Jimblebar Hub Significant Amendment: Response to Submissions

Table 1: Response to EPAS Comments, dated 11 April 2025

Table 2: Response to Public Submissions

JIMBLEBAR SIGNIFICANT AMENDMENT REQUEST FOR INFORMATION RESPONSE Vertebrate Fauna Survey Coverage

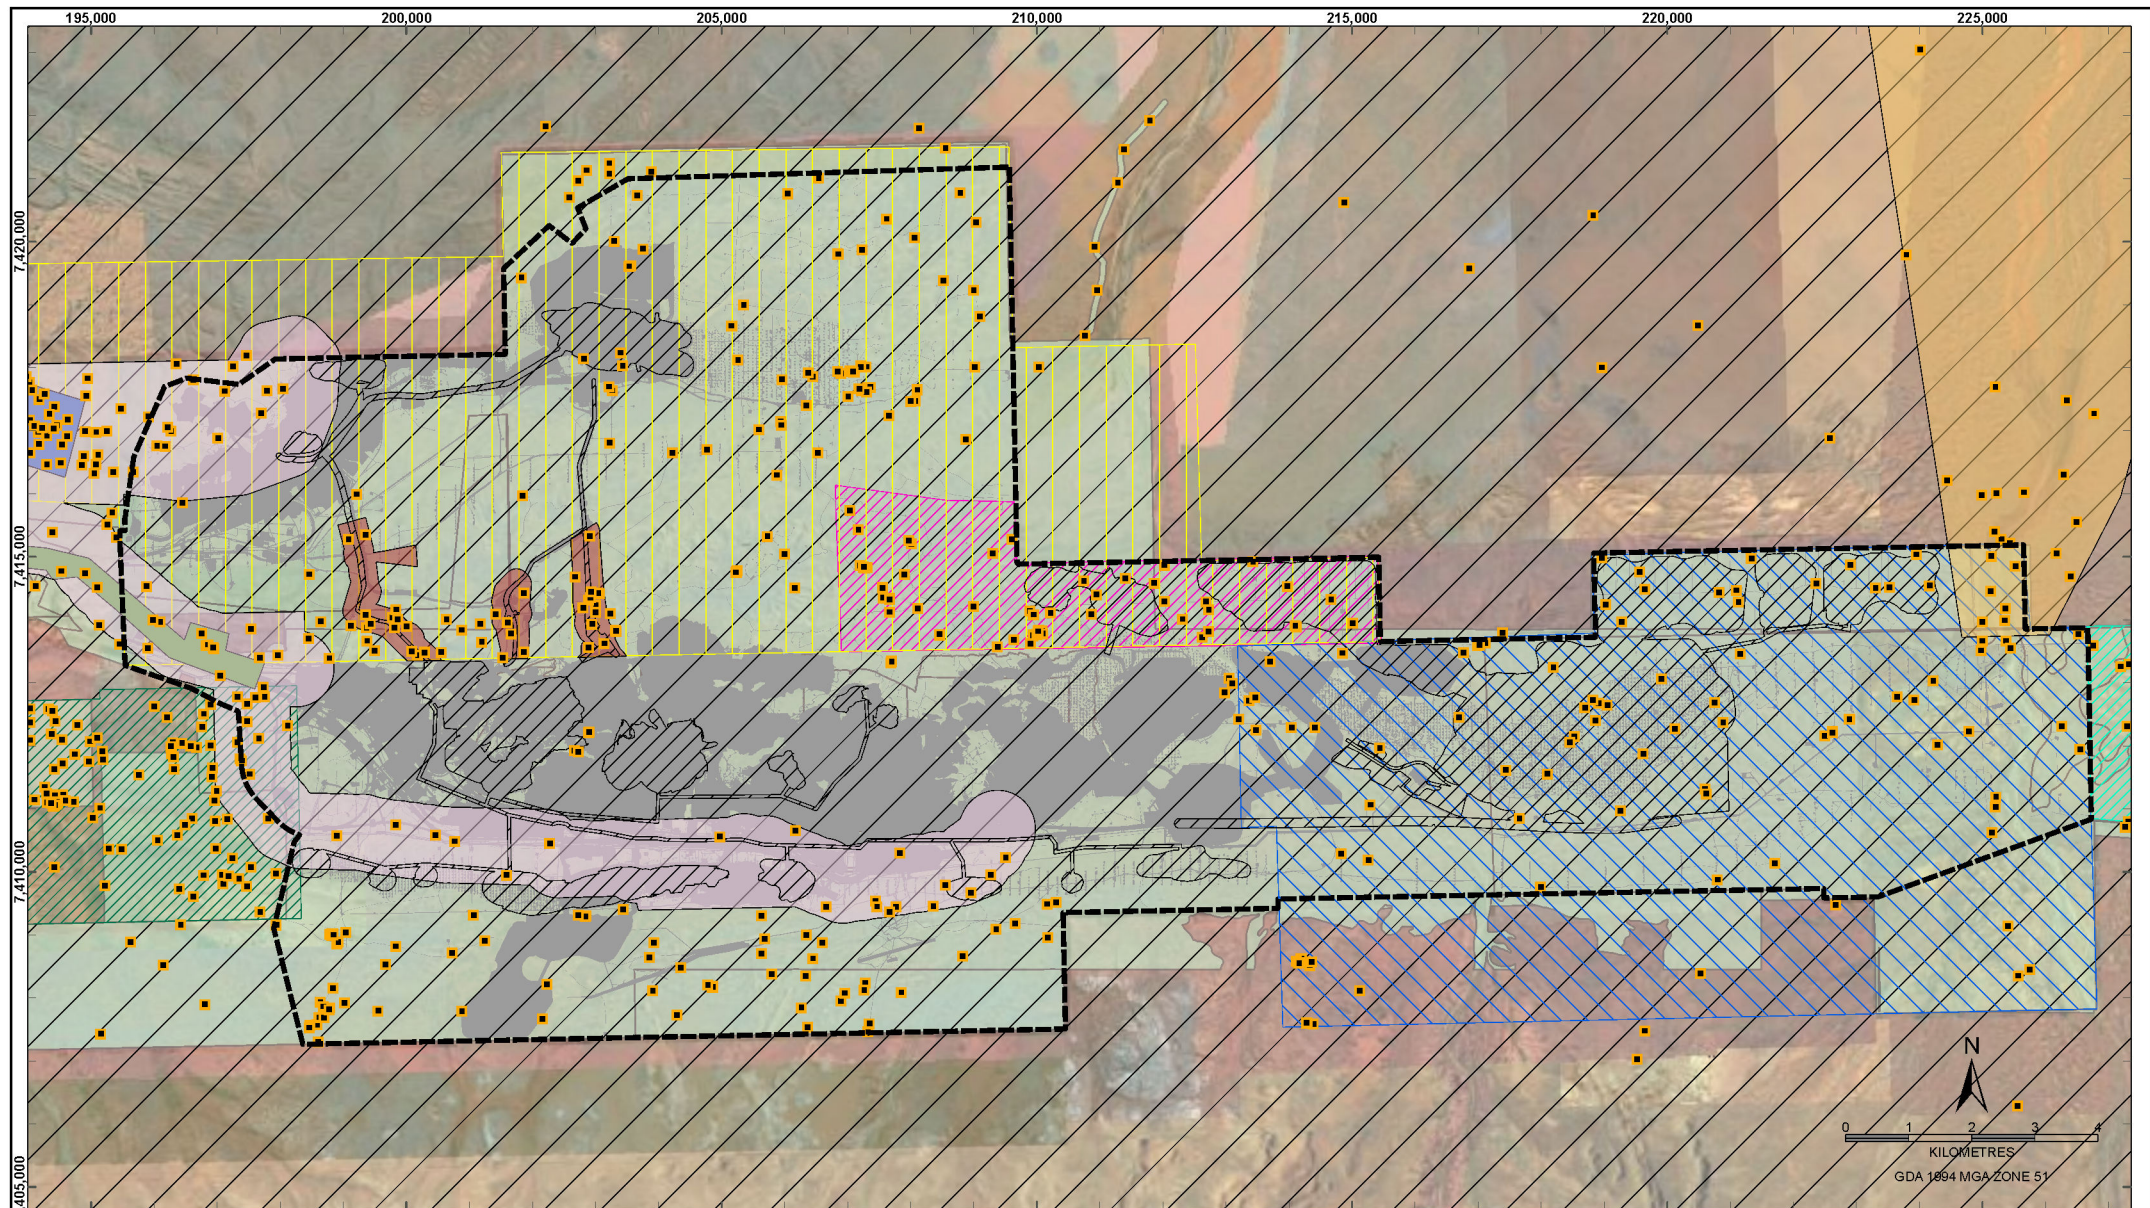
11.	DWER	Given the footprint is indicative and may change, all areas within the DE are required to be surveyed and a consolidation of survey effort should be undertaken. Inadequate presentation of survey effort prevents adequate impact assessment to be undertaken as the indicative footprint may change. Action: - Demonstrate adequate fauna surveys were undertaken, including mapping survey effort, including sampling types (sites and methods) in relation to fauna habitat and the indicative footprint. For example, it is unclear how extensive cave searches were undertaken in the eastern portion of the DE where Overburden Storage Areas (OSAs) are proposed (Appendix 12.8, Figure 2). - Provide a consolidation of fauna surveys. Figure 1 in the Additional Information provided demonstrates historical vertebrate fauna survey effort across the DE, however, this figure provides limited information i.e. it does not demonstrate survey names, dates or methodology type and is not mapped in relation to fauna habitat.	BHP has provided all relevant information in the ERD and supporting appendices. A consolidated survey report is not provided as this would duplicate information already provided. Areas north of the proposed OSAs is off tenure and has therefore not been surveyed. Aerial imagery indicates that the same fauna habitats extend north and outside of the Development Envelope boundary. BHP has provided the additional Astron Greater Bilby survey in Attachment 3. Attachment 4 Figure 1 provides historical fauna survey coverage.

JIMBLEBAR SIGNIFICANT AMENDMENT REQUEST FOR INFORMATION RESPONSE SRE Invertebrate Fauna Survey Coverage

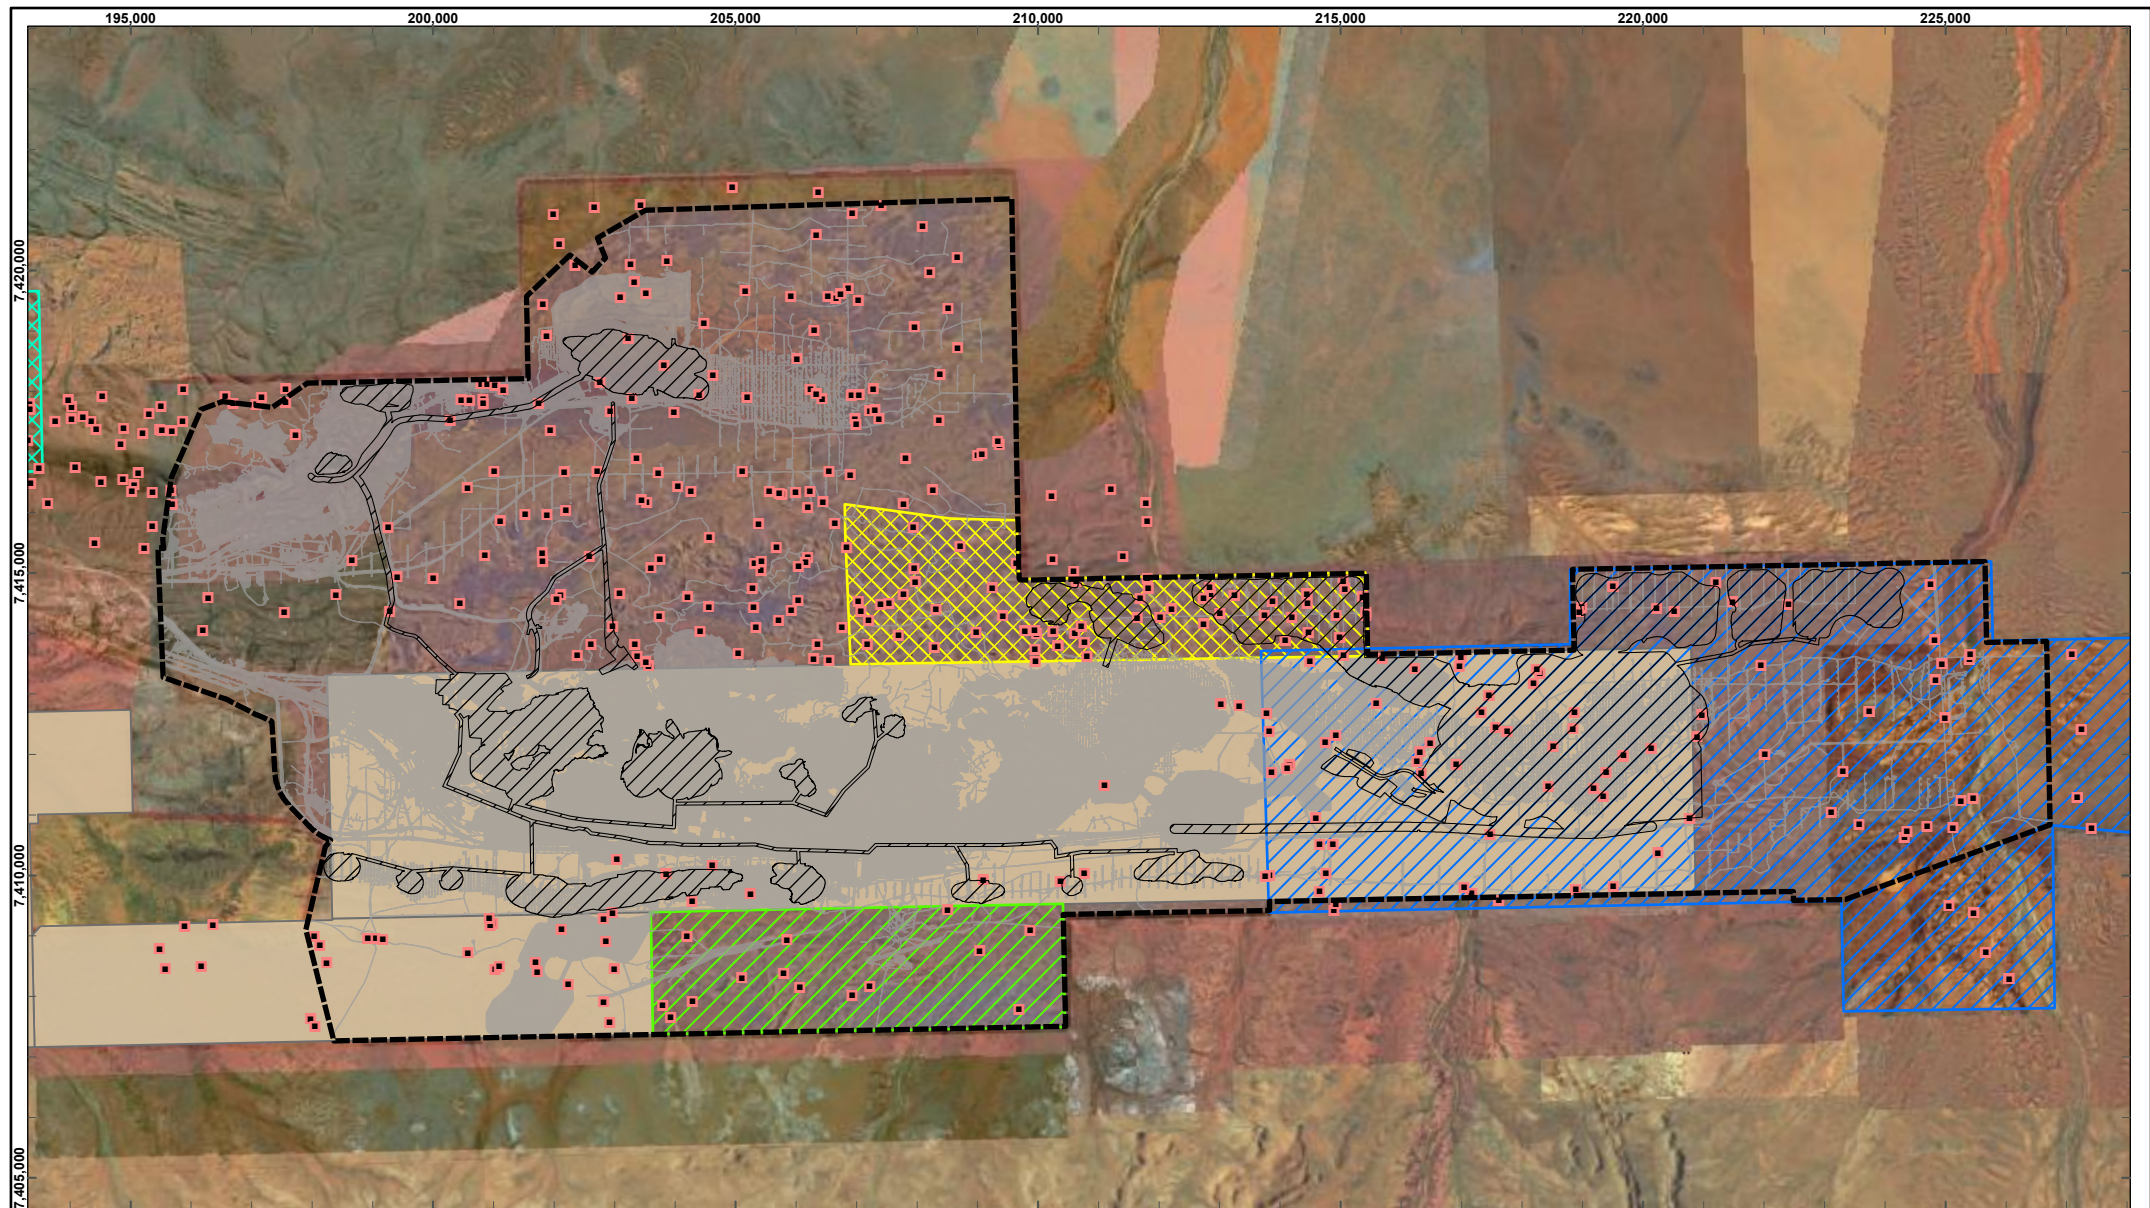
16.	DWER	Current information continues to be insufficient for assessing cumulative impacts of the proposal on terrestrial fauna. Figure 2 (attached to the previous Additional Information provided) has been provided to demonstrate historical short-range endemics (SRE) survey effort across the DE, however, this figure provides limited information. Current figures within the ERD (Figure 9-2) demonstrating SRE survey effort have not been revised, and sites and sampling methods have not been specified. In addition, there is no figure demonstrating SRE records previously recorded within the DE. Action: Clarify whether surveys have been undertaken across “previously assessed areas”, and present this information in relation to fauna habitat and the proposed footprint so that adequate impact assessment can be undertaken.	Figure 2 supporting the Request for Further Information demonstrates that nearly all of the Development Envelope has been subject to SRE surveys. In addition, Figure 9-2 of the ERD demonstrates recent SRE surveys within additional areas of the Development Envelope. Combined, these surveys cover the majority of previously assessed areas and proposed additional areas. Gaps in survey effort occur over Orebody 17/18 approved by MS439 in 1997 (as amended in 2008, 2013, 2015); and two areas in the western portion of the Development Envelope that coincide with the Jimblebar rail loop and underly proposed tailings pipeline and are already largely disturbed. See Attachment 4 Figure 2 SRE Fauna Survey Coverage.

JIMBLEBAR SIGNIFICANT AMENDMENT REQUEST FOR INFORMATION RESPONSE Flora and Vegetation Survey Coverage

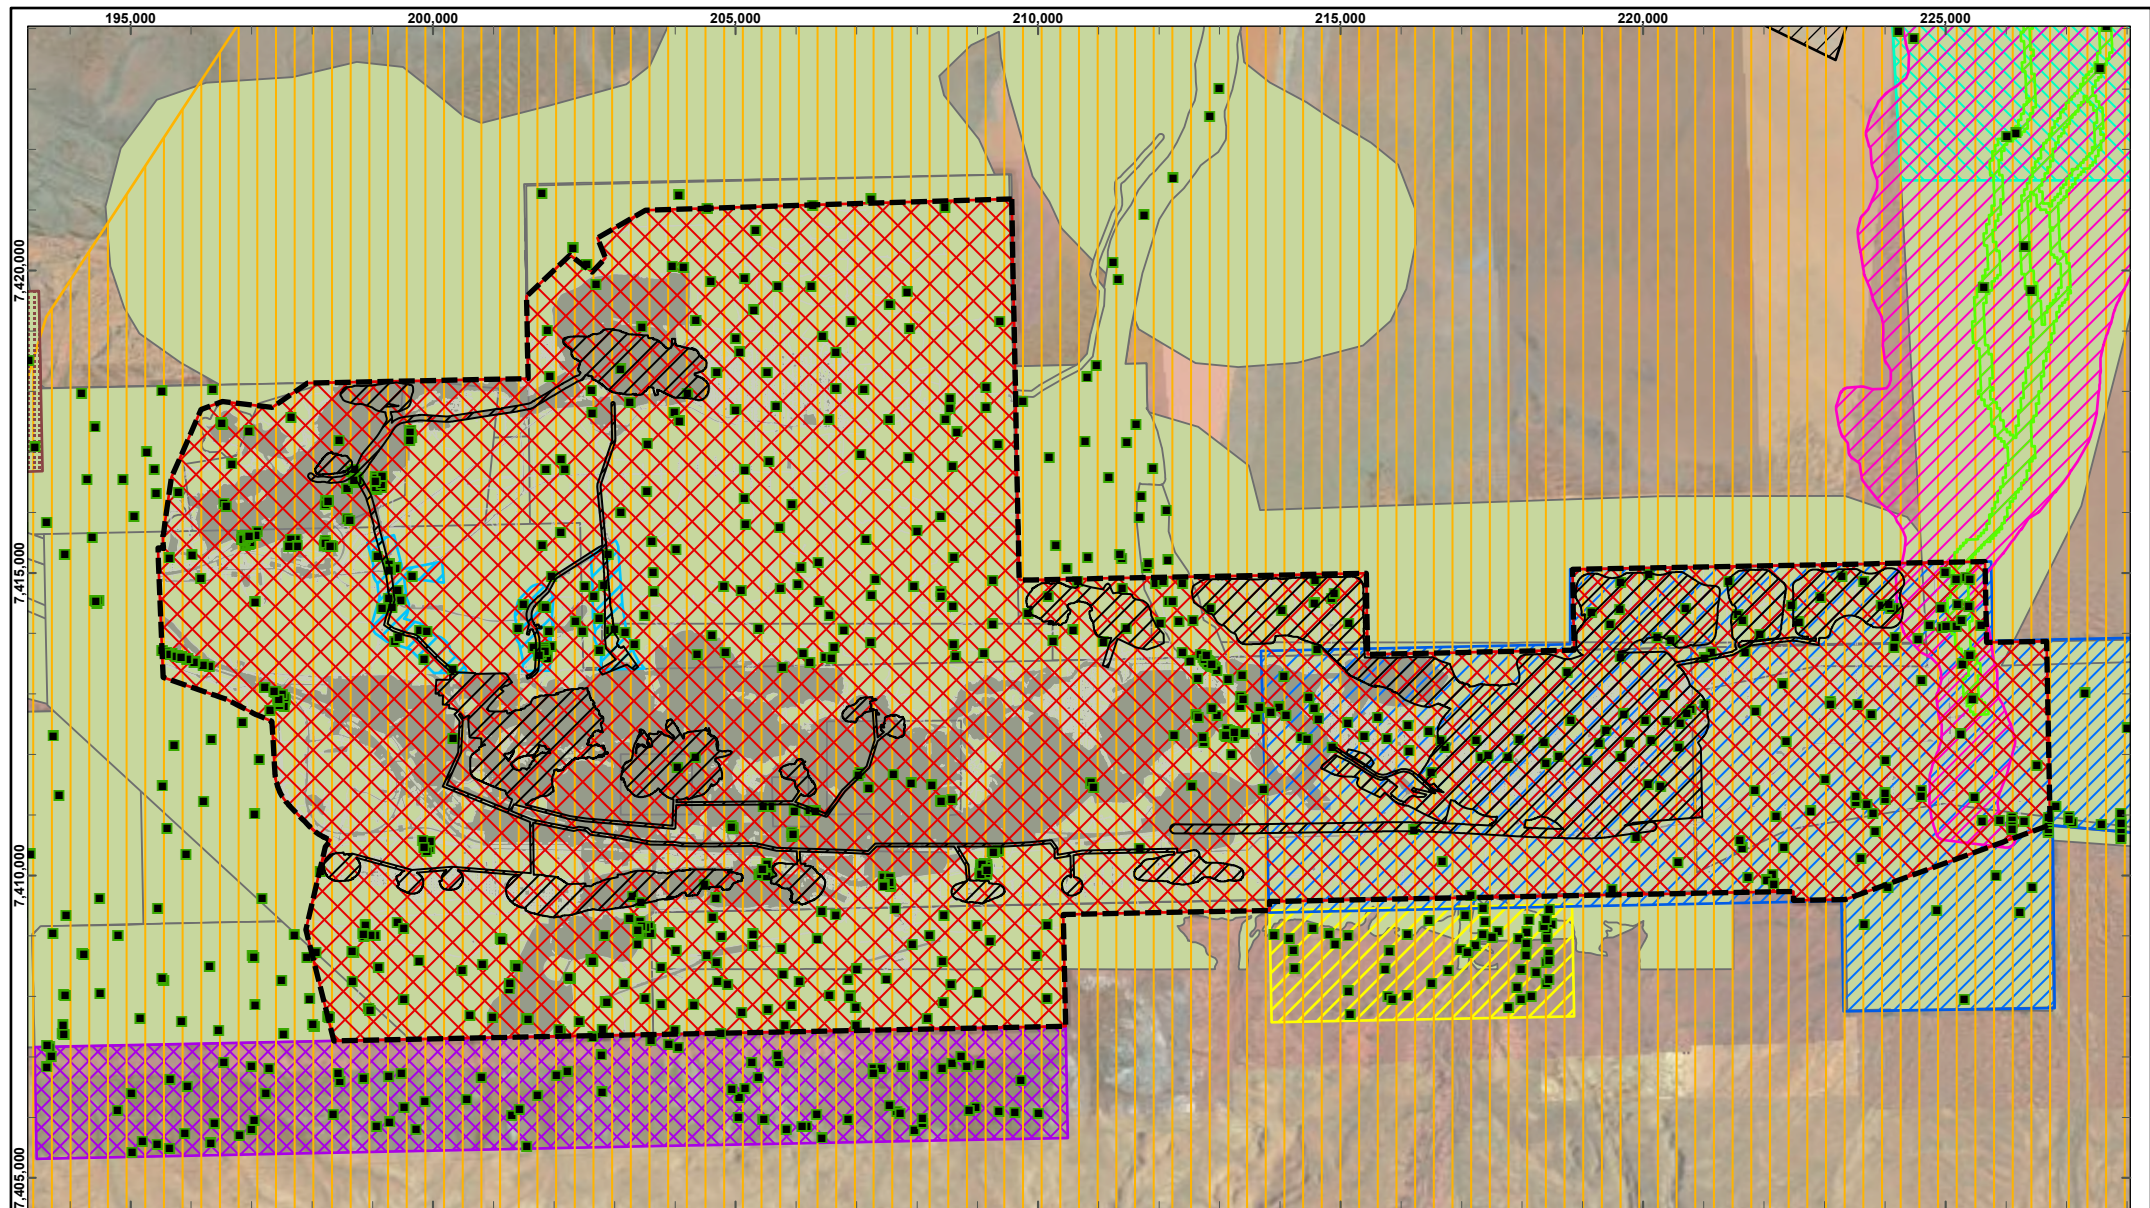
Comment number	EPA Services Comments	Proponent Response
Flora and Vegetation		
1.	Impacts to priority flora at the state level have not been provided in Table 8-7. Actions: To ensure an adequate quantitative impact assessment on priority flora, undertake a review of all available online databases and spatial tools to provide the statewide data of priority flora which have been recorded or are likely to occur within the development envelope. Provide impacts to priority flora at the state level.	In Table 8-7 of the ERD, BHP provides known populations and records of Priority flora based on BHP data in addition to publicly available information such as the DBCA records from the Pilbara and Gascoyne regions. Data is provided from these regions as it represents the regional population and predicted impact in the regional context. No further data is provided for the following four Priority flora species given their known distributions are limited to the Pilbara and Gascoyne regions. These are: <i>Acacia corusca</i> - only occurs in the Pilbara <i>Eremophila capricornica</i> - only occurs in Pilbara and Gascoyne <i>Rhagodia</i> sp Hamersley - only occurs in Pilbara and Gascoyne regions <i>Vittadinia</i> sp. Coondewanna Flats - only occurs in the Pilbara For the remaining three Priority flora species, the distributions extend outside of the Pilbara and Gascoyne IBRA regions. These are described below. The predicted impacts of the Combined Proposal on the known records using both BHP and DBCA data (as provided in Table 8-7 of the ERD) for the Gascoyne and Pilbara regions are as follows: <i>Aristida jerichoensis</i> var. <i>Subspinulifer</i> occurs in Pilbara, Gascoyne, Murchison and Central Ranges – 2.1% <i>Euphorbia inappendiculata</i> var. <i>Inappendiculata</i> is known from the Hamersley subregion of the Pilbara and west of Halls Creek in the Kimberley in the Central Kimberley – 0% <i>Triodia</i> sp Mt Ella occurs in Gascoyne, Pilbara and Little Sandy Desert – 1.5%

Comment number	EPA Services Comments	Proponent Response
		No further information is provided as the predicted impacts are low and representative of regional impact. Note for additional information, Attachment 4 Figure 3 provides historical survey coverage.
